MERCURISER SERVICE BULLETIN

Section: 11 (Installation)
Number: 363-06
Date: 4/29/63

- A. Transom Thickness Required for MerCruiser Installations
- B. Installation of Throttle, Shift & Ride-Guide Steering Cables
- C. Shift Cable Adjustments
- D. Competitive Remote Controls
- E. Engine-to-Drive Alignment
- F. "Hot Start" Problem & Remedy
- G. Automatic Choke Adjusting
- H. Engine Box Clearance & Vent

Figure 1. Ideal 2" Thickness

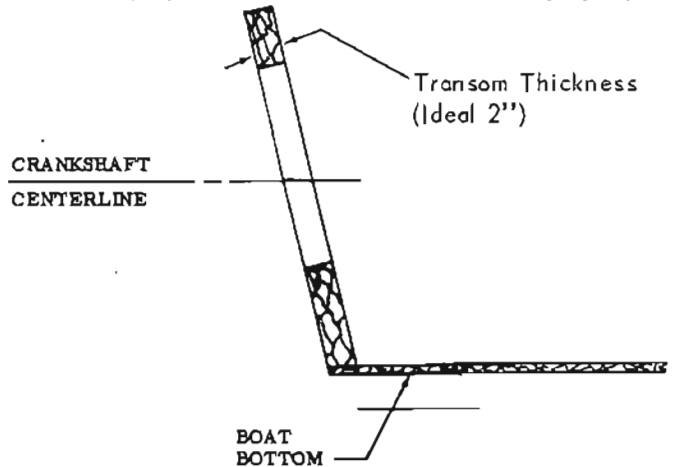
Transom thicknesses must be as follows:

1. MerCruiser I Stern Drive Unit - 1-3/4" min. to 2-1/4" max.
2. MerCruiser II Stern Drive Unit - 1-7/8" min. to 2-1/8" max.

If above transom thickness limits are not observed, the drive will not function properly. Transom must be of uniform thickness so that front and rear surfaces are parallel. Always check transom thickness before installing transom plates.

Figure 2. MerCruiser I Stern Drive Unit Ride-Guide Cable

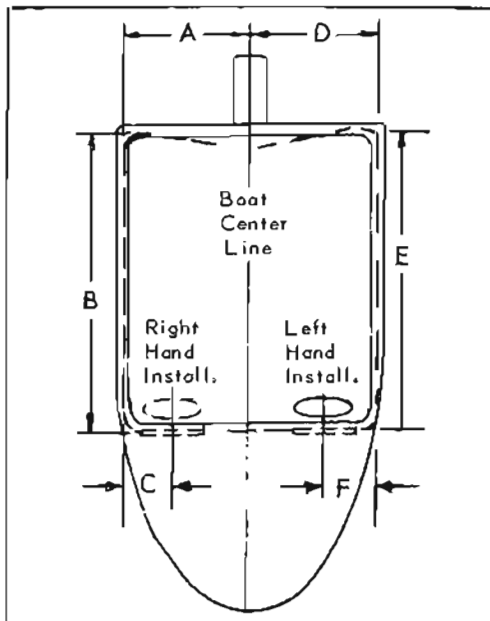
Ride-Guide cable can be routed down right or left hand side of boat:

1. Add boat measurements A-B-C in inches for right hand installation.
2. Add boat measurements D-E-F in inches for left hand installation.
3. Subtract 30" (this allows for 12" radii at each cable bend).
4. Divide by 12".
5. This is cable length in feet.* (Order 34415A - cable only.)

NOTE: C & F dimensions must not be less than 18".

Figure 9. Engine Aligning Tool

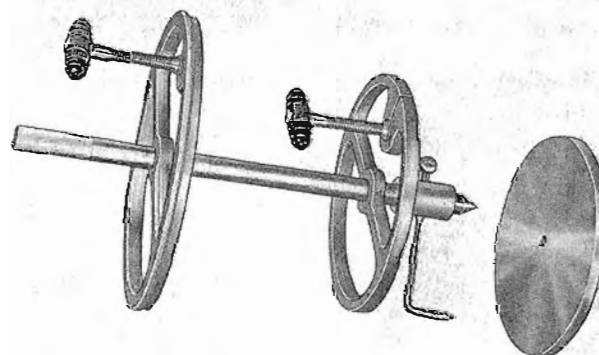
It is necessary to use Alignment Tool 91-31620A1 when installing MerCruiser II Stern Drive Units. (Figure 9) This tool may be purchased direct from your parts distributor or the Kiekhaefer Corporation branch in your area.

Damage will occur to drive unit and engine coupling unless alignment instructions are followed.
